3			2			1			APPROVALS				TITLE		
PROJ. DESIGN	PROJ. MANAGER	OTHERS	PROJ. DESIGN	PROJ. MANAGER	OTHERS	PROJ. DESIGN	PROJ. MANAGER	OTHERS	PROJECT MANAGER	OTHER	DATE	ENGINEERING	DATE	CONDUIT PLAN DIAGRAM	
Madson Lakomek & Associates			Madson Lakomek			Madson Lakomek			Madson Lakomek		4/30/23		4/30/23		
DATE	4/18/23		DATE	4/30/23		DATE	4/30/23		RELAY			LAYOUT BY	DATE

DRAWING NUMBER	REQUEST FOR WORK/NO	PROJECT DOCUMENT LIST

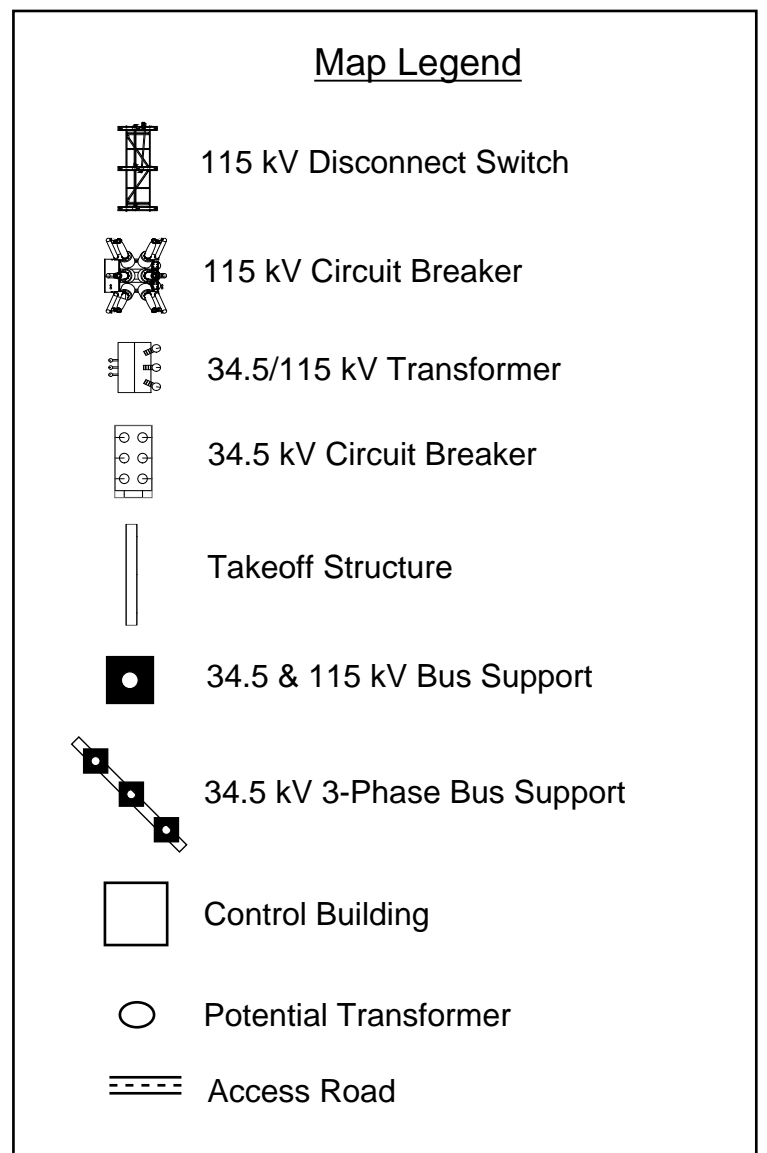
- Added labels to specify which conduit wire was meant for which function of the components - Added a key to explain conduit labeling - Changed trenching to be at 45 degree angles instead of 90 degrees - Included the PVC that connects 34.5 kV circuit breakers so they did not go under the equipment - Added trenching - Included the PVC pipes connected to each piece of equipment															
MADE BY	DATE	ACT	RELAY	MADE BY	DATE	ACT	RELAY	MADE BY	DATE	ACT	RELAY	PROJECT DESIGN/ACT	DATE	LOCATION NAME	
ML & BN	4/18			ML	4/30			ML	4/30					Roswell Solar Field Substation	
CHK. BY	DATE	EP&PM	APVD. FOR ISSUE	CHK. BY	DATE	EP&PM	APVD. FOR ISSUE	CHK. BY	DATE	EP&PM	APVD. FOR ISSUE	OTHERS	DATE	SERVICE CENTER	
														NONE
